**Vern Freeman Dam Fish Passage
Conceptual Design Report
- FINAL -
September 15, 2010**

Prepared for: United Water Conservation District

Prepared by: Vern Freeman Dam Fish Passage Panel

APPENDIX D: Panel's Response to Comments Received on the July 30, 2010 Draft Report

Figure 2.2-2. Example current hydrograph-based operation of VFDD in response to a large-sized storm.

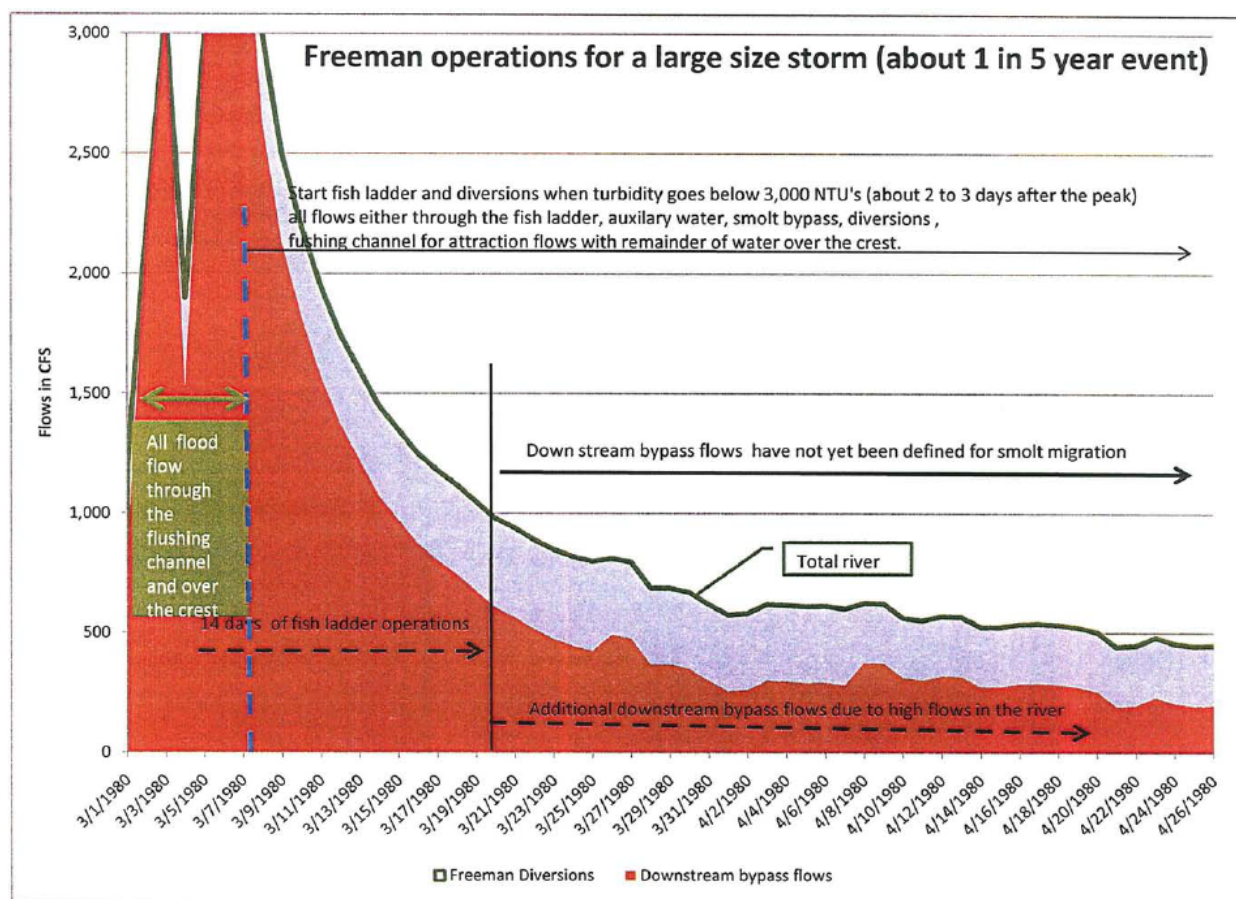
Comment #	From	Document Section (Para #)	Context	Comment	Suggested Text (from reviewer)	Panel Response
7	NMFS	Fig 2.2-2	Page 2-10	How will sediment management change with the various alternatives? For instance, under current operations, the fish ladder is not operated when the turbidity is > 3,000 ntu - will this operation criteria remain?	-	Sediment management will likely be very similar between all alternatives with all alternatives designed to operate at high turbidities because they are separated from the canal and will not cause high sediment loads to the canal or diversion facilities. So the existing operation constraint of not providing fish passage when turbidity is higher than 3,000 NTUs will not remain with the new alternatives. Design features are included in all of the alternatives to enhance or maintain sediment management opportunities (e.g., silt flushing to maintain open conveyances). Sediment transport performance through specific components may vary between alternatives (e.g., the ramps and nature-like fishway may retain residual sediment deposits that require monitoring or maintenance) but not likely to the point that there will be significant management differences among the alternatives.

Figure 3.2-1. Spawning migration route up to the ascendograph's spawning destination: from the Pacific Ocean up to the Upper Sespe Creek Mainstem at the mouth of Howard Creek at RM 61.

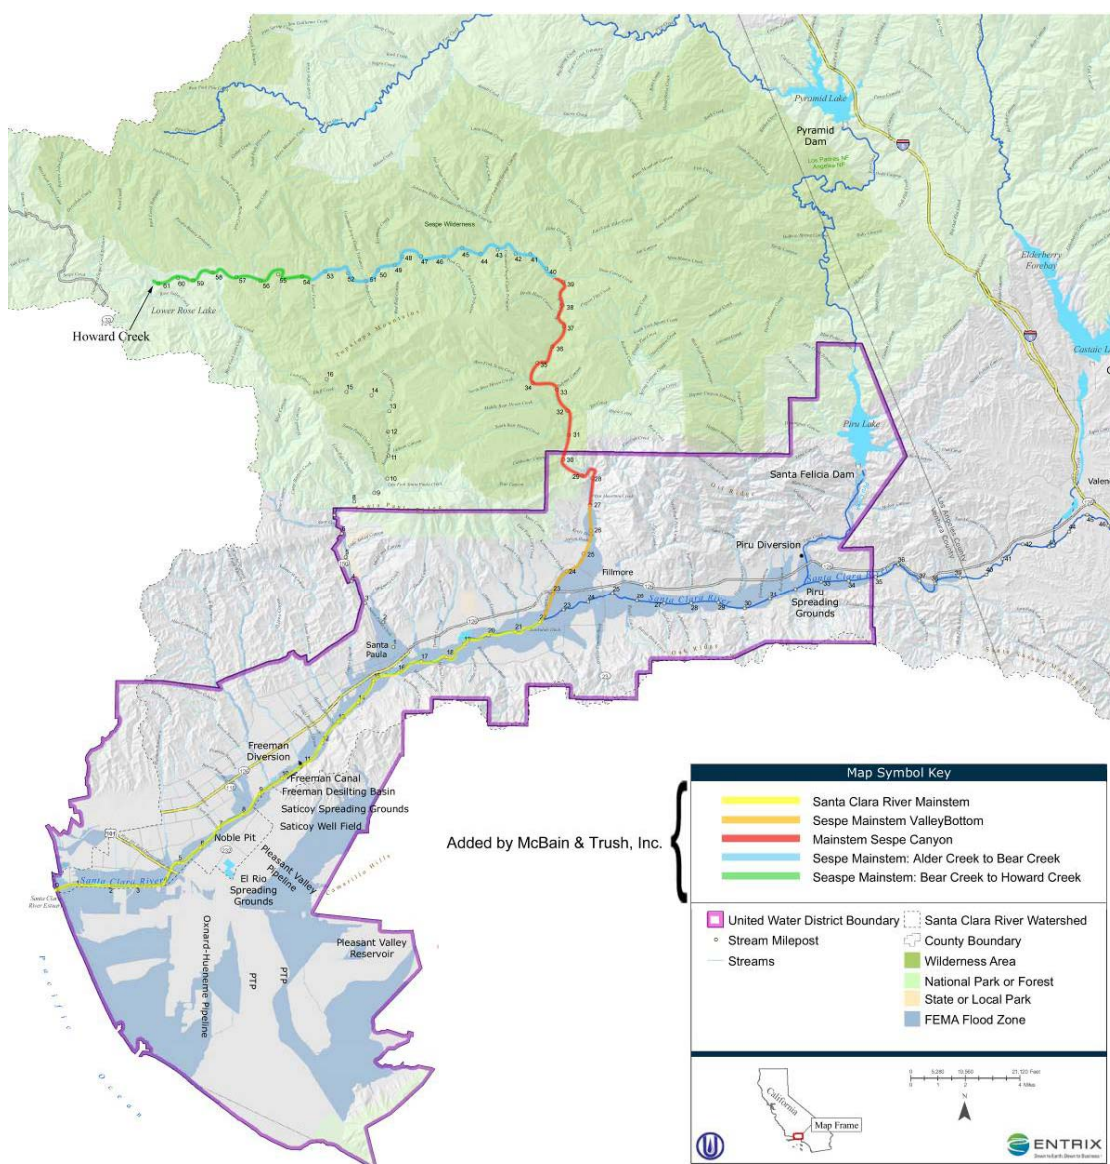
39	UWCD	Figure 3.2-1	-	It's hard to distinguish between red and orange on the map	-	Comment noted.
40	UWCD	Fig. 3.2.7 and 3.2.8	Graphs	The graphs show the total successful days based on the "Fast Migration Baseline" and the "Slow Migration Baseline" The results show that a fish in 2003 would be more successful at the slow migration rates than the faster migration rates. If correct, please provide and explanation why.	-	Yes. Basically, the SLOW scenario gives the fish much more time in which to reach the spawning destination. The ascendograph modeling was more sensitive to the extended duration in which to be successful than sensitive to a higher daily average migration rate.
41	UWCD	6.1	last paragraph on page 6-1	Dam removal will result in channel stability...	Dam removal more likely will result in channel instability at least for some period	Agree, text edited.

Figure 3.2-7. Effect of passage barrier flows on total spawning success under FAST migration modeled in the ascendograph for WY2001, WY2003, WY2005, and WY2006 at a single spawning destination, Upper Sespe Mainstem at Howard Creek (Modeling Scenario No. 1).

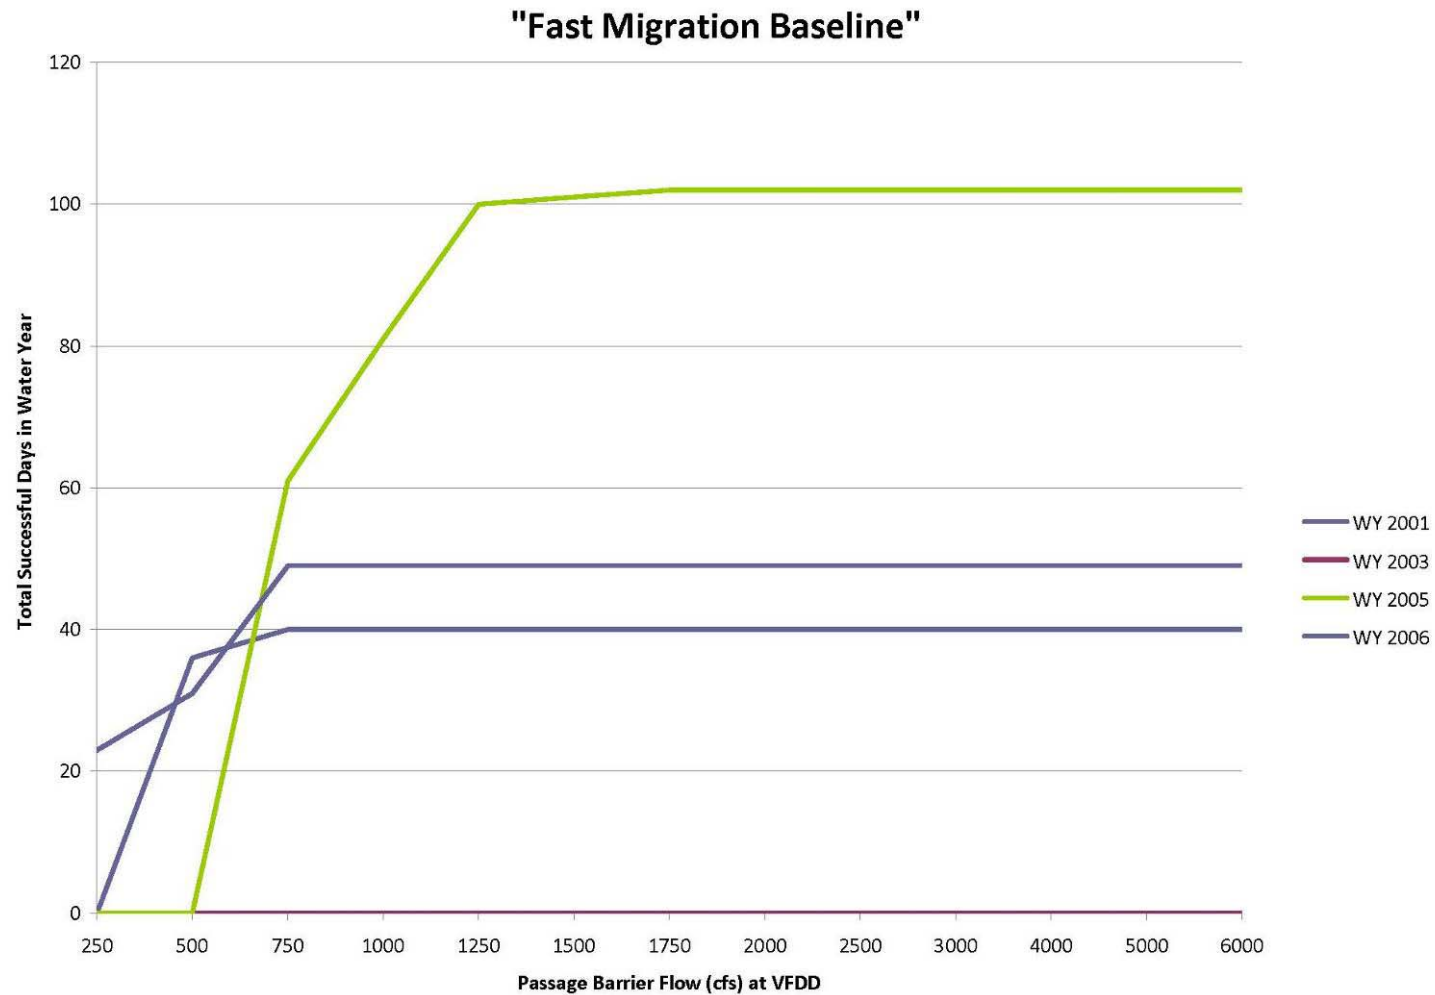
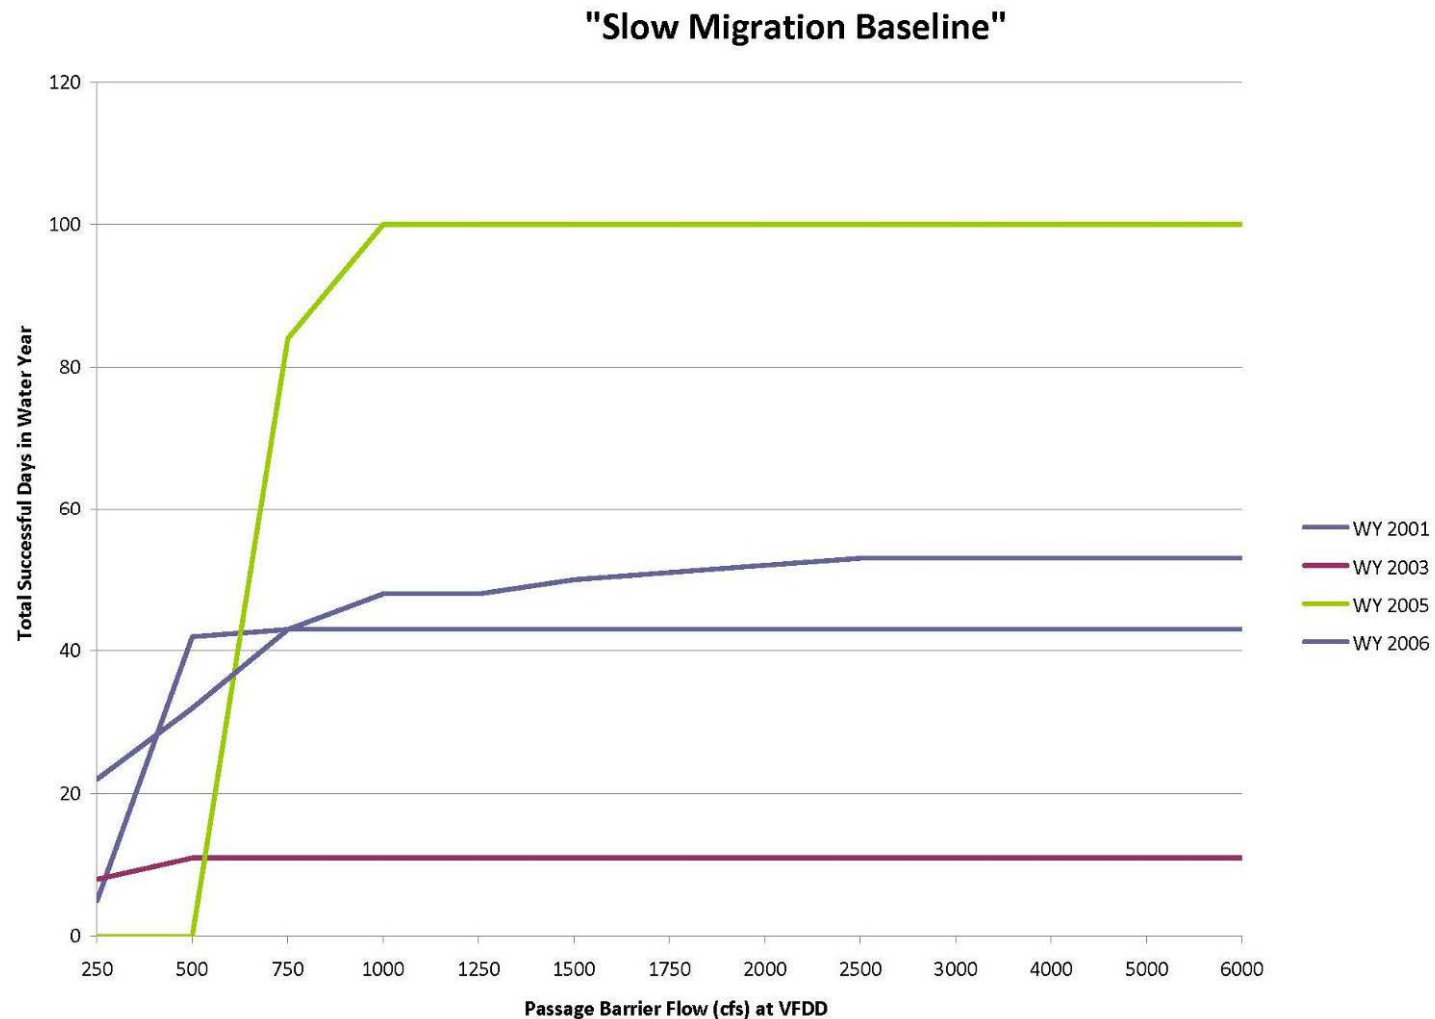
Comment By	Document Section (Para #)	Context (or Paragraph#, Sentence#)	Comment	Suggested text
UWCD	Fig. 3.2.7 and 3.2.8	Graphs	The graphs show the total successful days based on the "Fast Migration Baseline" and the "Slow Migration Baseline" The results show that a fish in 2003 would be more successful at the slow migration rates than the faster migration rates. If correct, please provide an explanation why.	
UWCD	6.1	last paragraph on page 6-1	"Dam removal will result in channel stability..."	Dam removal more likely will result in channel instability at least for some period
UWCD	6.1	general	Issues which are understandably beyond the Panel's scope are real. The social and water management challenges with the dam removal option cannot be overstated. Adding some numbers may help provide some perspective on why this alternative is complicated from a water supply angle.	United has diverted an average of 78,000 AF per year since the diversion was built in 1991. During this time Lake Piru has provided an average annual available storage of 29,000 AF. More than half of this water is delivered to the upper basins leaving the Freeman Diversion with about 15,000 AF on average. This would represent an 80% loss in diversions to an already over drafted basin. Additionally water reliability would go down because the diversions could no longer rely on the upper basins drainage via rising groundwater during the droughts. The diverted yield from the Santa Clara (non-Piru) watershed helps support the water needs of a population of over 200,000 and a globally important agricultural resource which produces \$1B in annual economic benefit.

Figure 7.1-2. Percent of downstream flow that is effective fishway attraction flow.

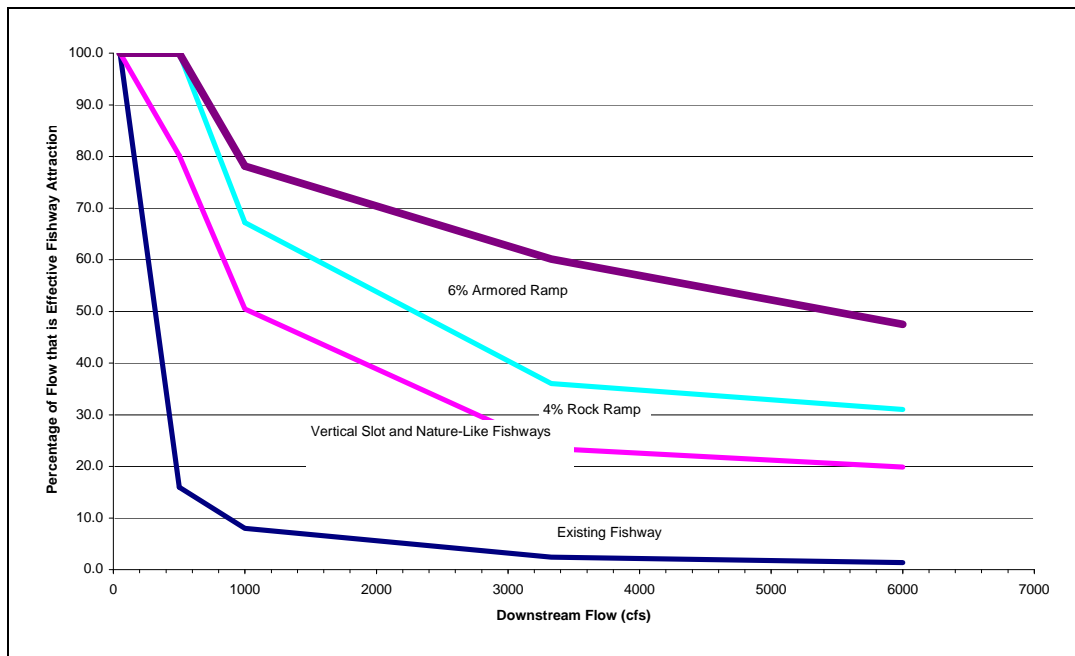
Com- ment #	From	Document Section (Para #)	Context	Comment	Suggested Text (from reviewer)	Panel Response
59	UWCD	Figure 7.1-2		It appears that the panel estimated the total attraction flow of the existing fishway to be around 80cfs. Please revise to show that the Ladder is capable of 40 cfs, the auxiliary 80 cfs, and in the past few years we have augmented the attraction with the sluice gate with another 150 cfs. That would bring a total attraction of 270 cfs. So at 1000 cfs in the river the graph should be showing around 27% attraction. If the rating system on page 7-14 was based on the incorrect attraction flows please revise.	-	Entrance flow was wrongly estimated at 80 cfs; corrected to 120 cfs. Sluice flow was assumed up to 4,000 cfs similar to other alternatives; corrected to current condition of 150 cfs. Final calc: $Q=80+40+0.4(150)=190$. Figure updated.
60	UWCD	7.1.1	Typo in first bullet on page 7-4	...an\ auxiliary water systems for attraction.	Delete "an"	Agree, text edited.
